**From:** Josephine Lowry#ns.aliantzinc.ca [josephine.lowry@ns.aliantzinc.ca]  
**Sent:** November 28, 2006 2:05 PM  
**To:** Myles,Debra [CEAA]  
**Subject:** Whites Point Quarry and Marine Terminal Project Description  
**Attachments:** Whites Point Quarry 7.0 PROJECT DESCRIPTION .pdf

# Whites Point Quarry & Marine Terminal

## *REVISED* PROJECT DESCRIPTION

Figure WCR - 4A

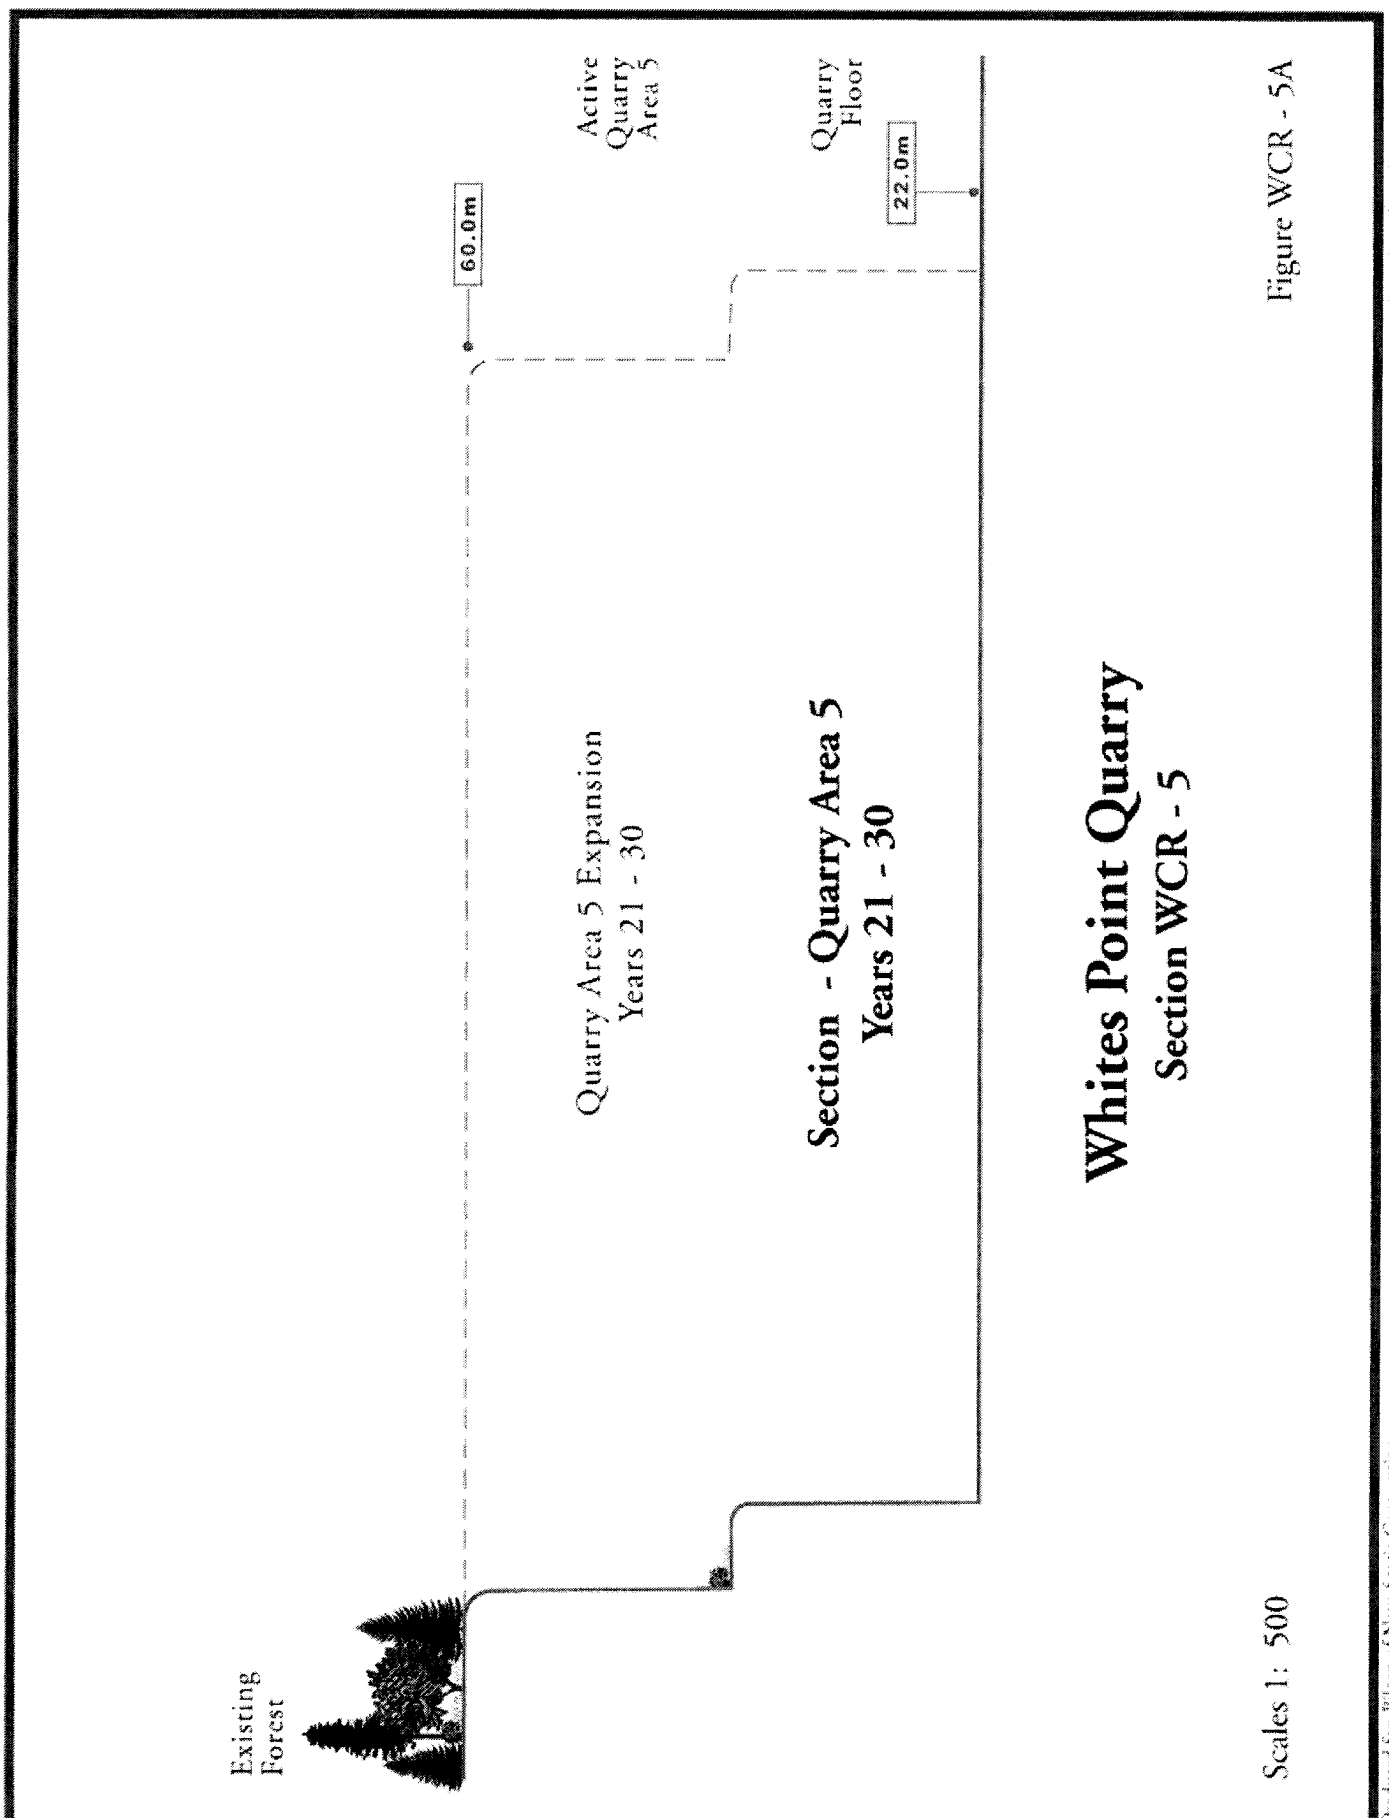
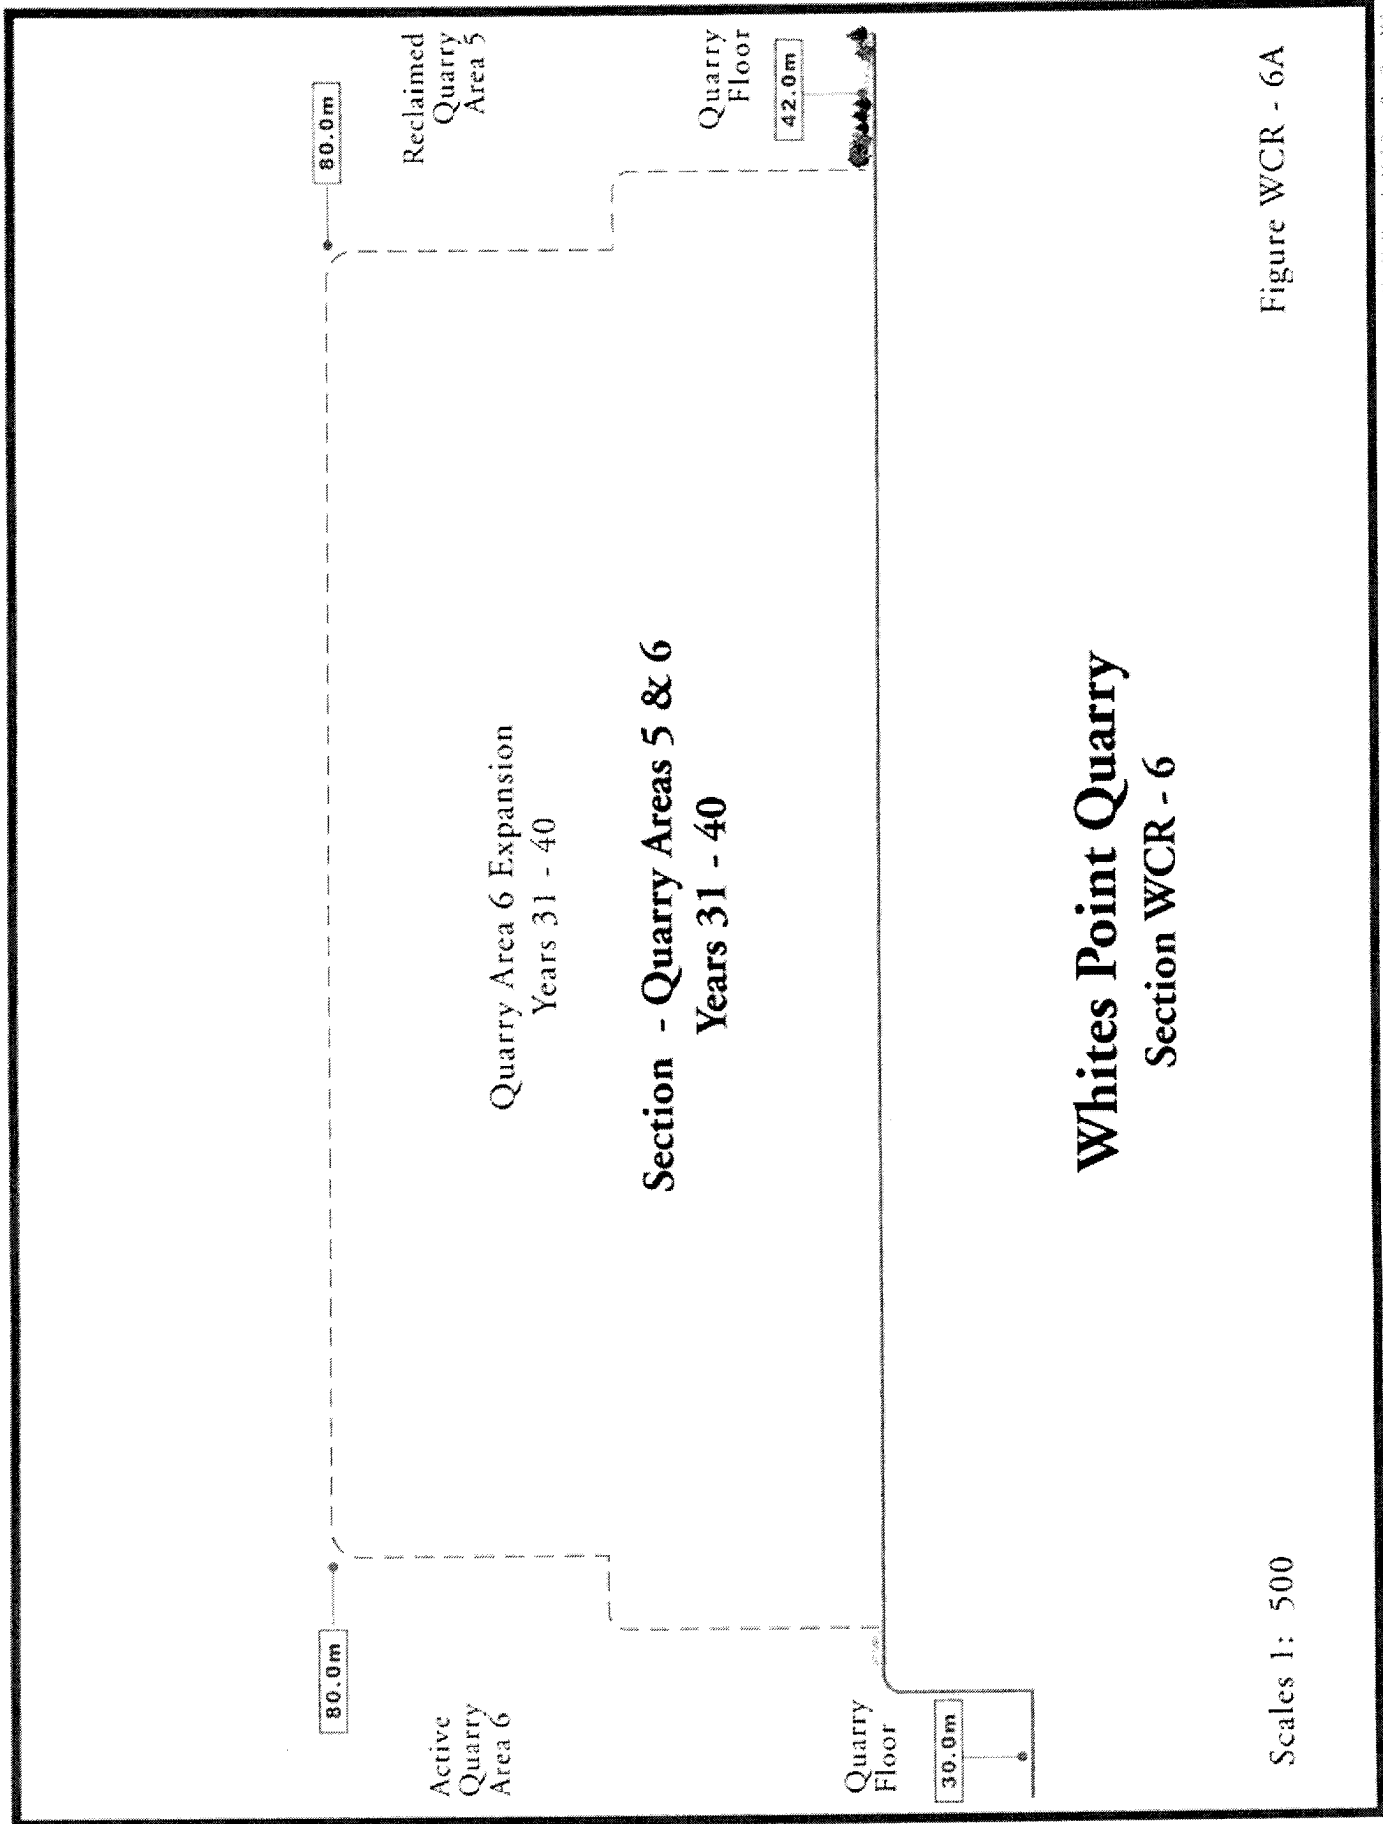
A series of sections are presented on **Figures WCR – 4, WCR – 4A, WCR – 5, WCR – 5A, WCR – 6 and WCR – 6A** to illustrate the quarry operation with and without the Whites Cove Road. The location of where the sections are taken is shown on the Concept Quarry Plans (Mine Plan) **OP4 – R1, OP5 – R1, and OP6 – R1**. Sections for the with and without scenarios are located at the 40, 60, and 80 meter contour elevations along the Whites Cove Road.

- During quarry operational Years 21 – 30, quarry area 5 will begin production. As a result of quarrying in area 5, the situation as shown on **Figure WCR – 5** will result. As shown at the 60m elevation, the existing topography and forest north of the Whites Cove Road will remain unchanged at this time and the quarry floor is approximately 38m below the road to the south.

- During quarry operational Years 31 – 40, quarry area 6 will begin production. As a result of quarrying in area 6, the situation as shown on **Figure WCR – 6** will result. As shown at the 80m elevation, the quarry floor is approximately 50m below the Whites Cove Road to the north and 38m below to the south.

- During quarry operational Years 21 – 30, quarry area 5 south of the Whites Cove Road will begin production. Quarry area 5 would be expanded into the road right-of-way and environmental preservation zone as shown on **Figure WCR – 5A**, at the 60m elevation.

- During quarry operational Years 31 – 40, quarry area 6 north of the Whites Cove Road would be expanded into the road right-of-way and environmental preservation zone. As shown on **Figure WCR – 6A**, at the 80m elevation, the floor of quarry area 5 and 6 will join.
